AGENDA FOR REGULAR MEETING VILLAGE OF TINLEY PARK PLAN COMMISSION

**MINUTES OF THE REGULAR MEETING OF THE
PLAN COMMISSION, VILLAGE OF TINLEY PARK,
COOK AND WILL COUNTIES, ILLINOIS**

PLAN COMMISSION STAFF REPORT

PLAN COMMISSION STAFF REPORT

SITE PLAN

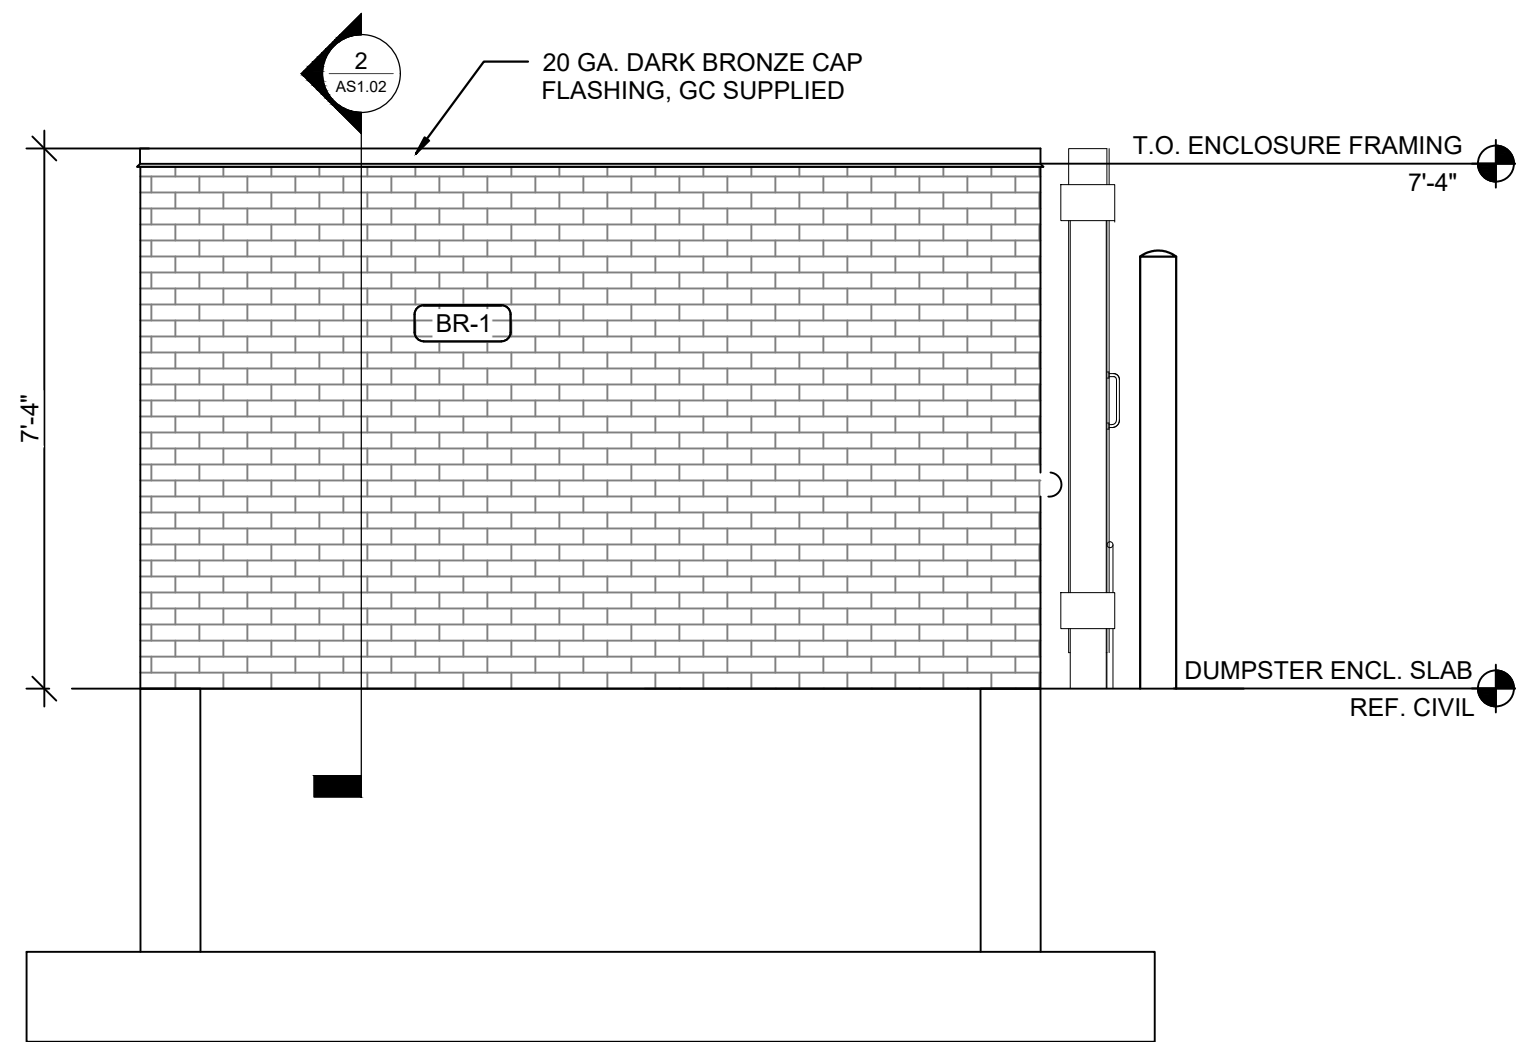
The parking and traffic were a primary concern staff and the developer has been reviewing and revising the plans to best address those concerns. The intersection can be very busy and has a history of traffic issues. There was originally a full access on 171st Street. Staff did not feel this worked and pushed for the right-in/right-out with raised curbing to prevent vehicles to make turns they should not do and could create traffic issues on 171st Street. Staff feels this plan will work with Cook County Dept. of Transportation and the Village Engineer. This should control the access in and out. The Petitioner's transportation expert (KLOA) will be available at the Public Hearing to discuss their report and answer any other specific questions.

With the 3,511 sq. ft. proposed convenience store requires 23 parking spaces per the Zoning Ordinance requirements. The proposed site plan provides 17 total spaces based on the similar retail requirements. Due to the unique nature of a gas station where some of the retail users may be stationed at the pumps yields the potential for 10 additional parking spaces. Customers are usually on the site for short periods, resulting in high turnover and thereby lowering the demand for parking. Staff believes that the parking supply is adequate on the proposed site.

1. Discuss recommended condition requiring the demolition and lot restoration of the two deteriorating vacant single-family homes south of the subject site (currently the same property owners).
2. Discuss Variation to reduce the minimum drive aisle width from 26 feet to 24 feet.
3. Staff is recommending a condition that site plan approval be conditioned upon final engineering review and approval.

Open Item #3: Staff is recommending a condition that site plan approval be conditioned upon final engineering review and approval.

EXTERIOR COLOR ELEVATIONS AND SCHEDULE

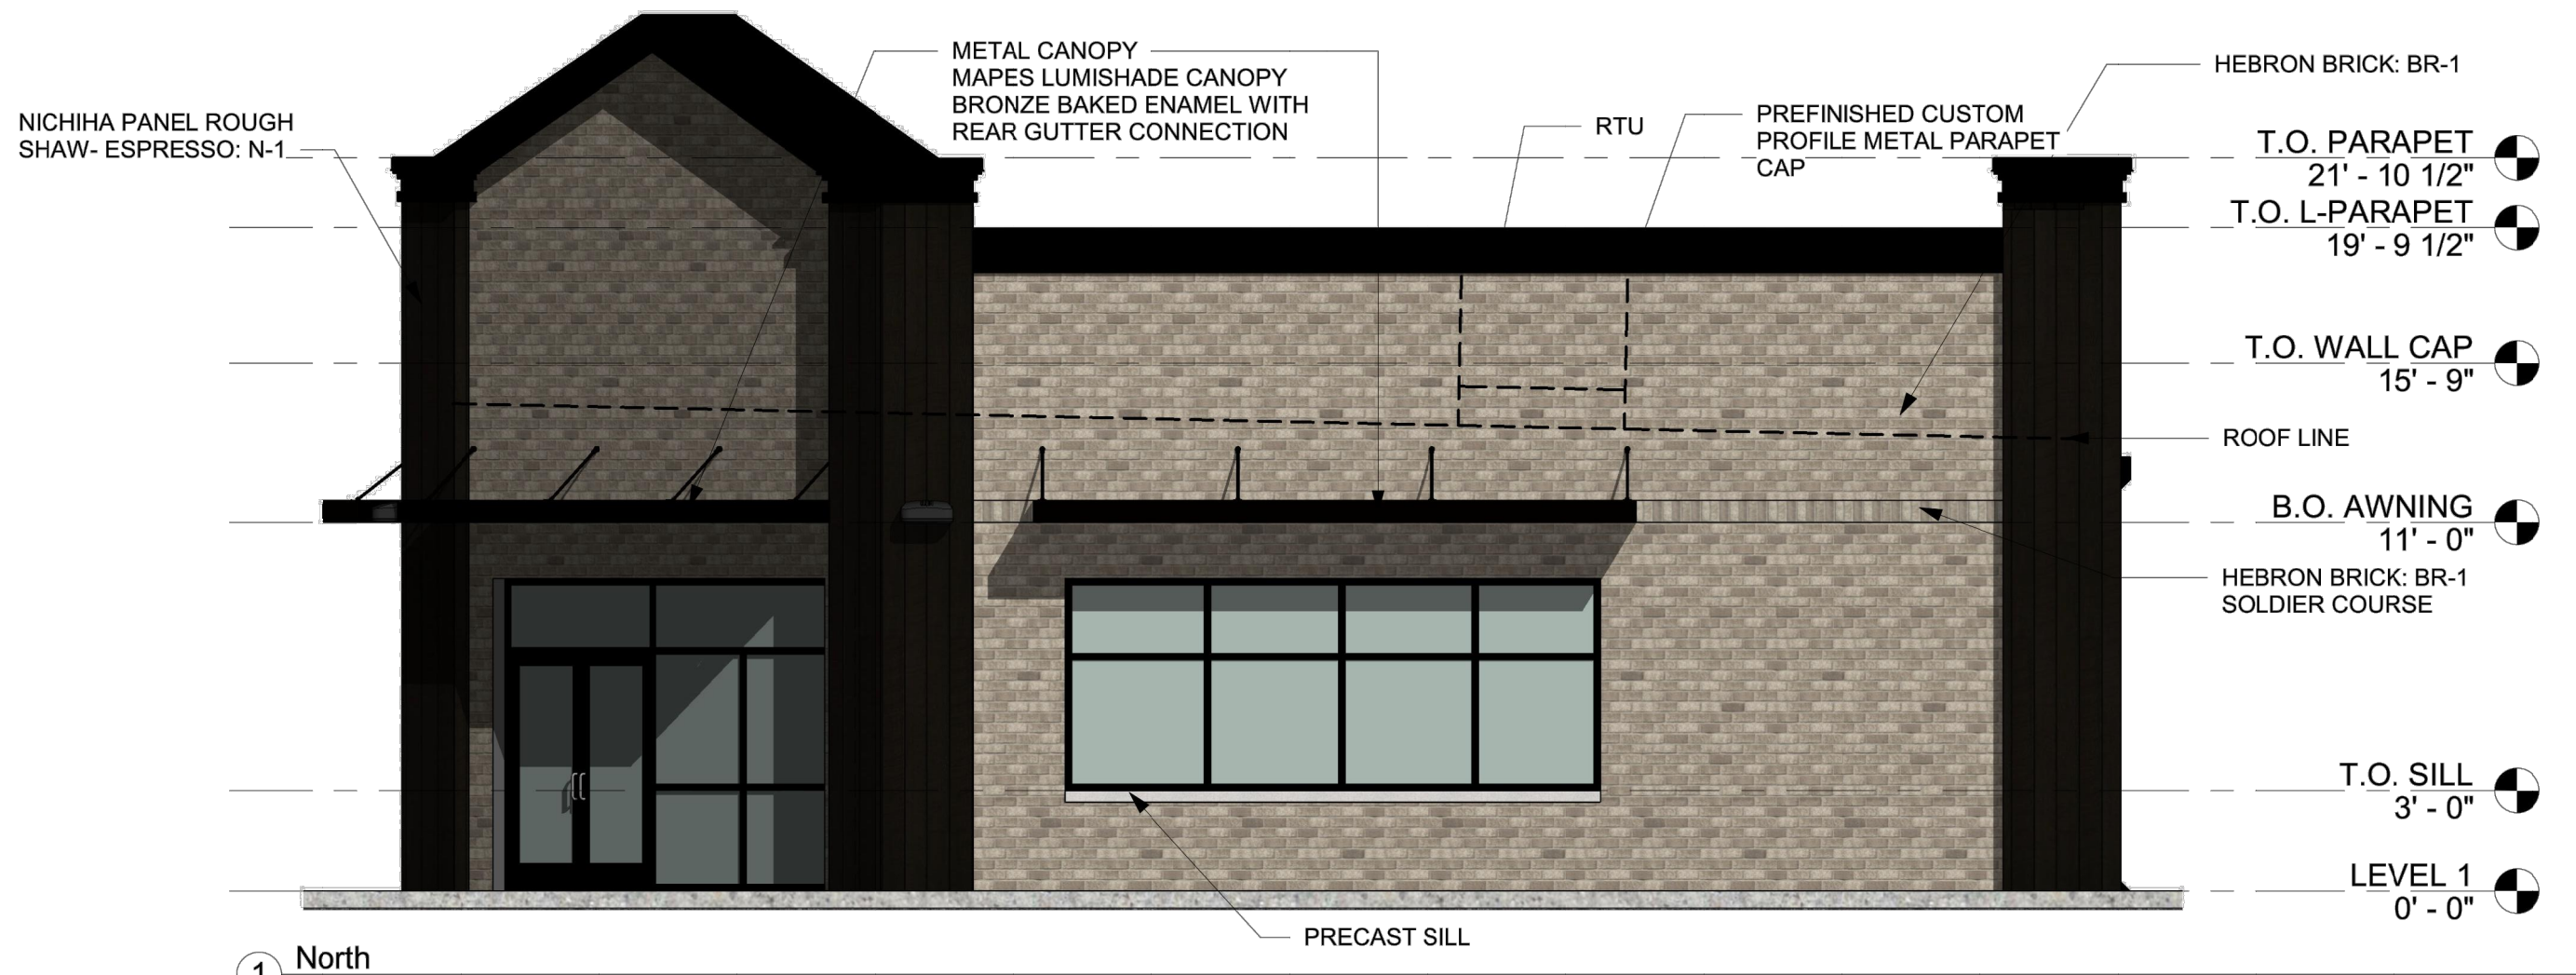
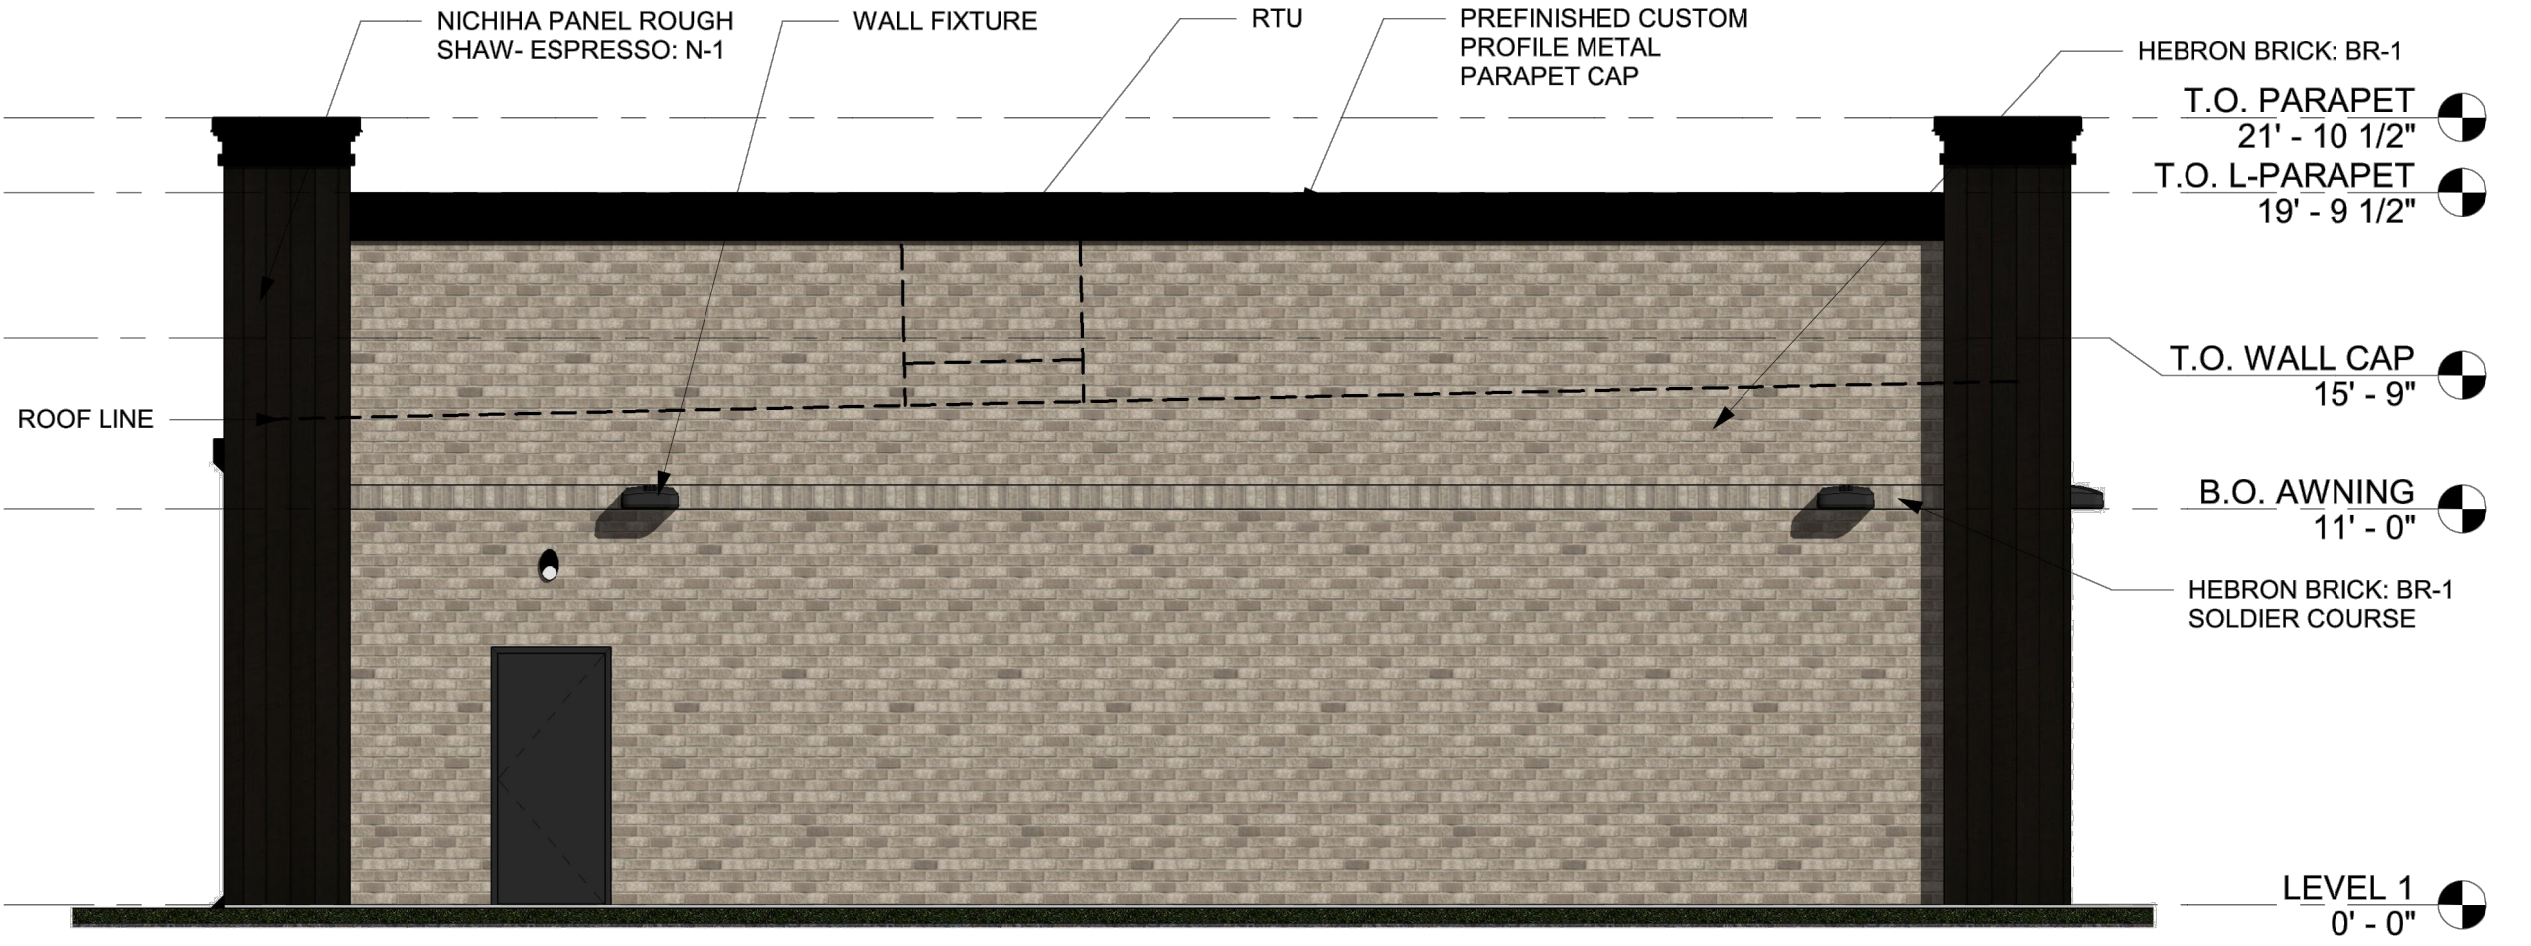
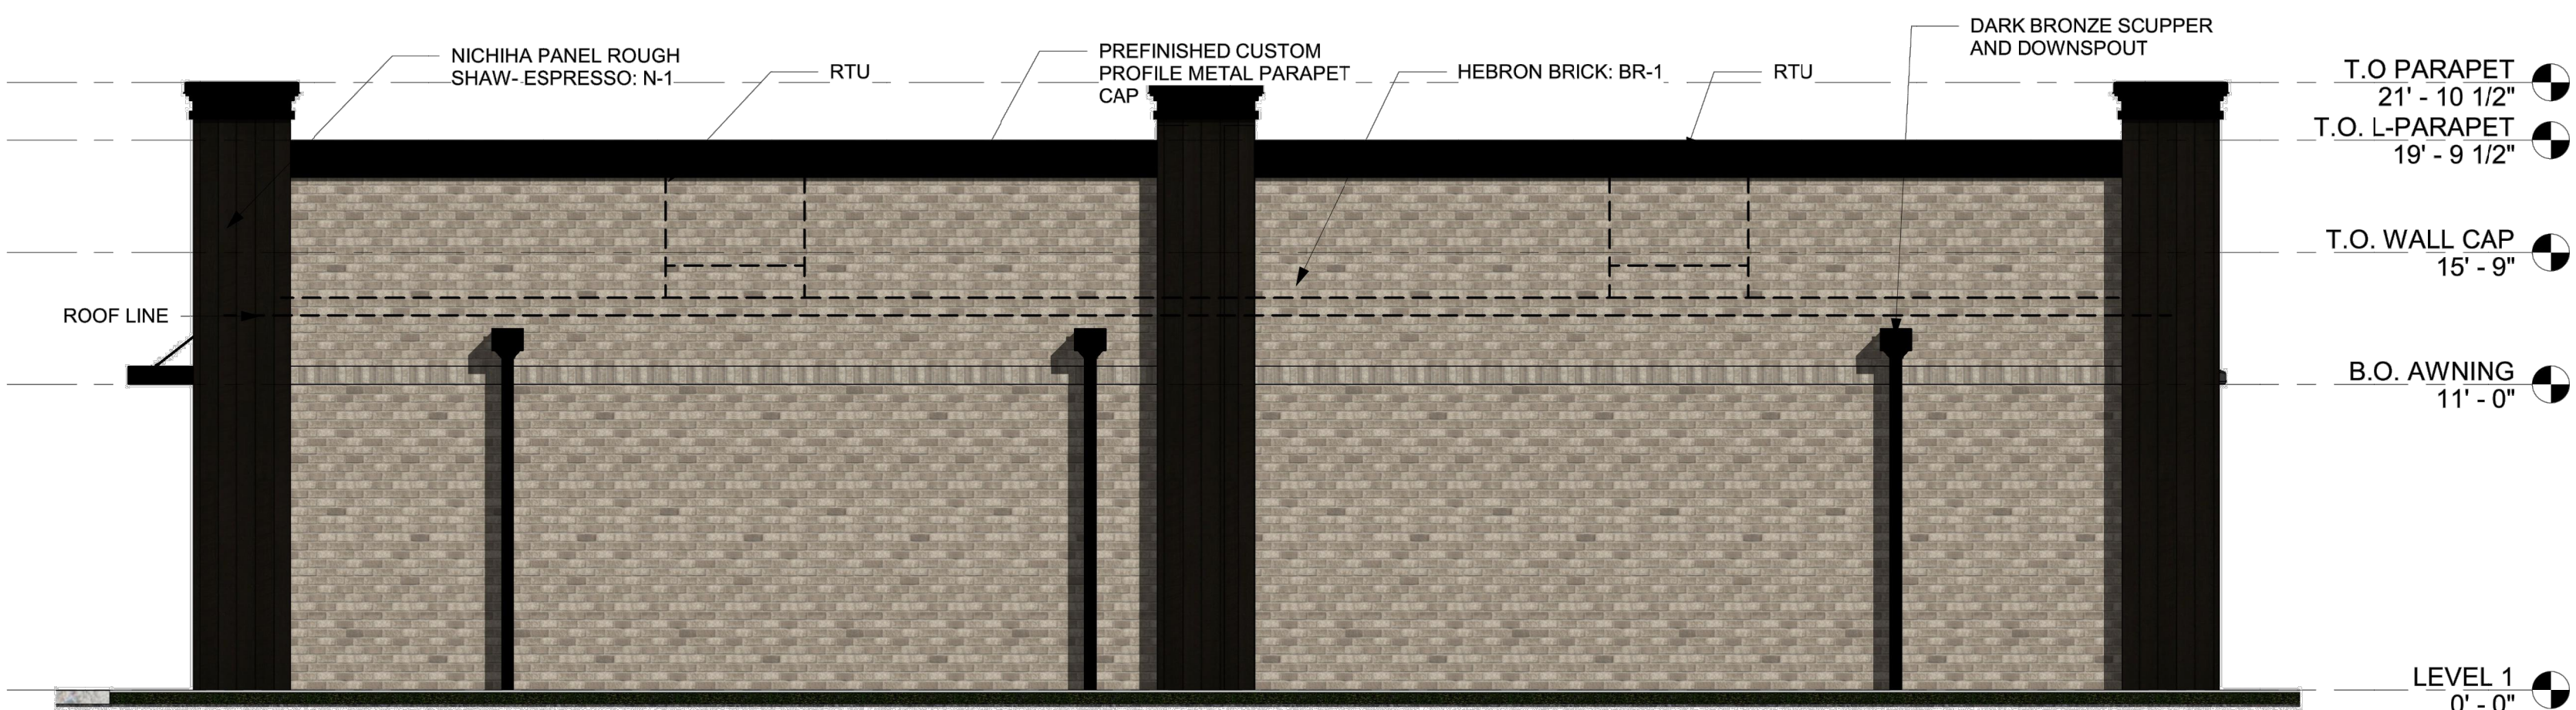
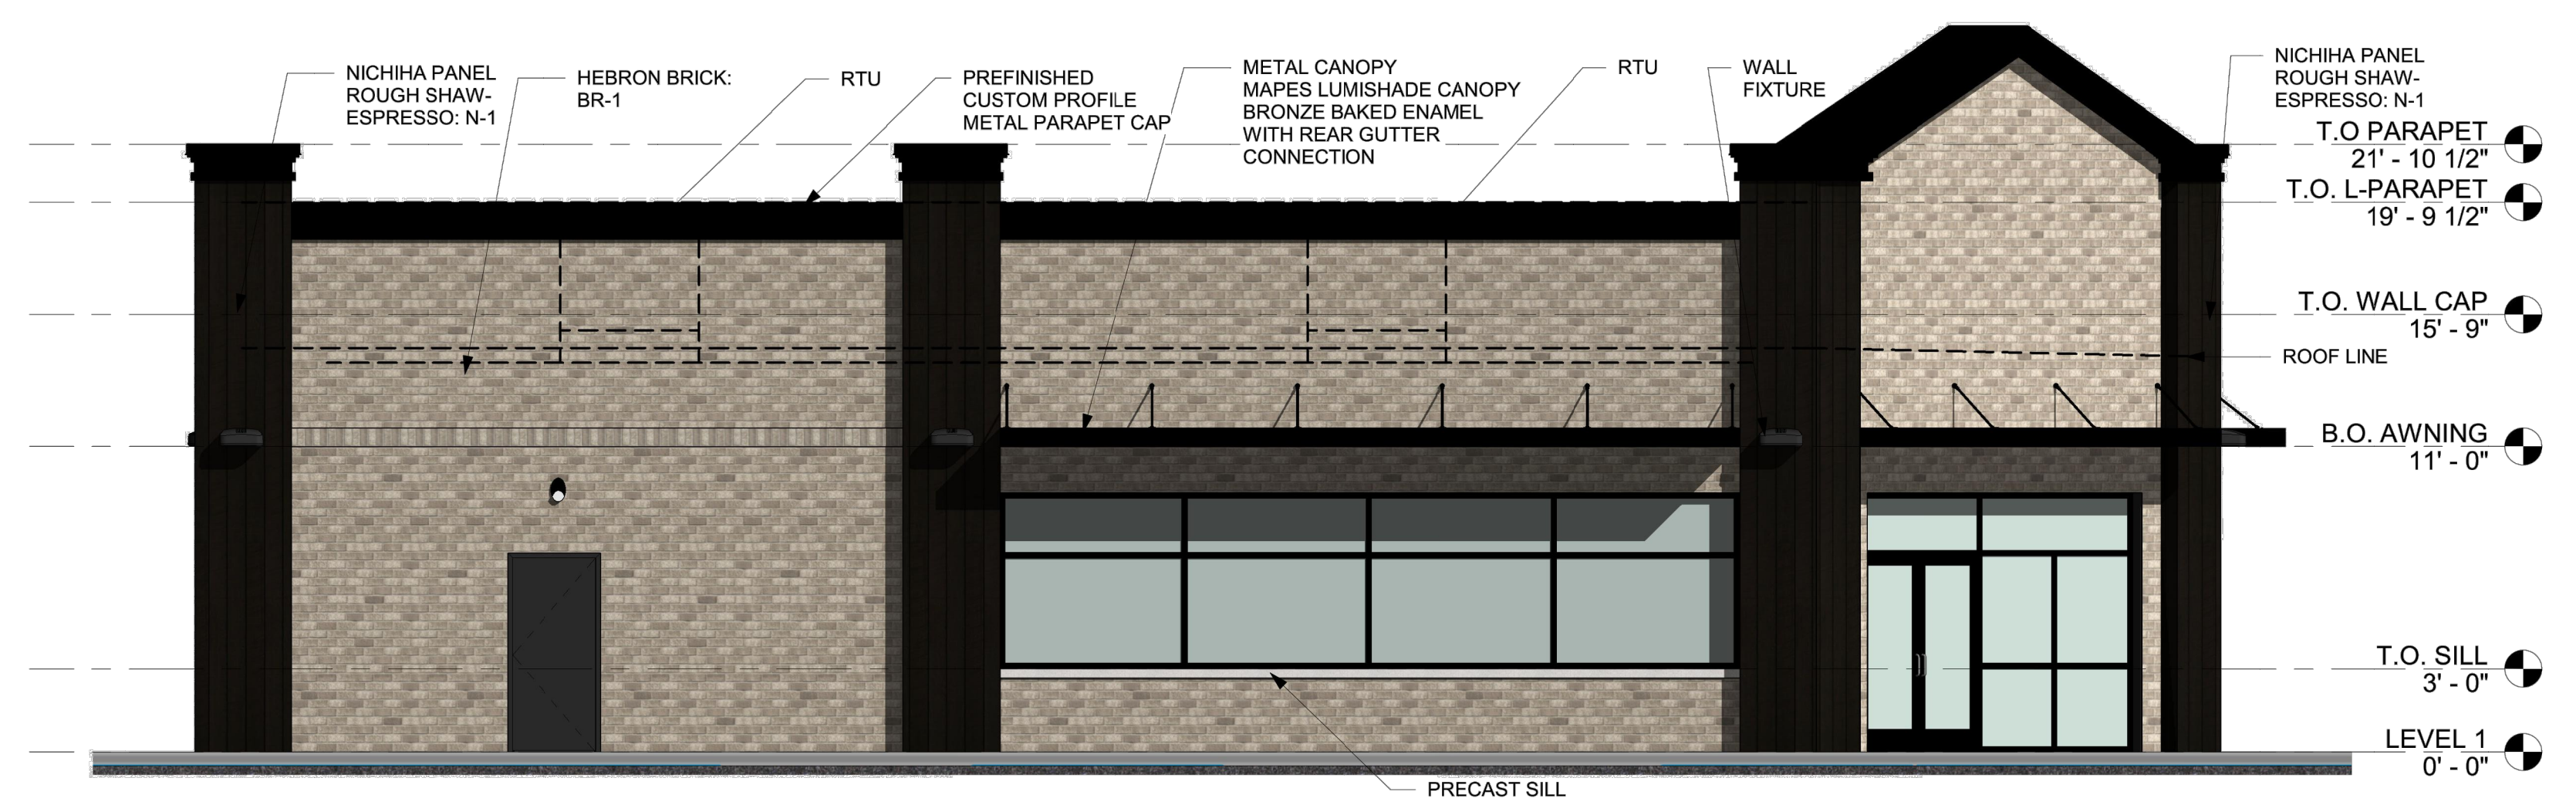
The design of the convenience store building and gas station canopy utilizes high-quality materials, including face brick with fiber cement and metal cornice architectural treatments. All mechanical equipment on the rooftop parapet will be screened. The architectural design is prototypical of 7-Eleven's new branding initiative. Staff recommended a more residential roof for the convenience store building, utilizing more residential elements such as shingles and peaks. A peak was added to the front entrance and caps to the architectural treatments to give a more traditional look to the building.

COMMISSIONER GATTO noted she liked the peak that has been added to the roof.
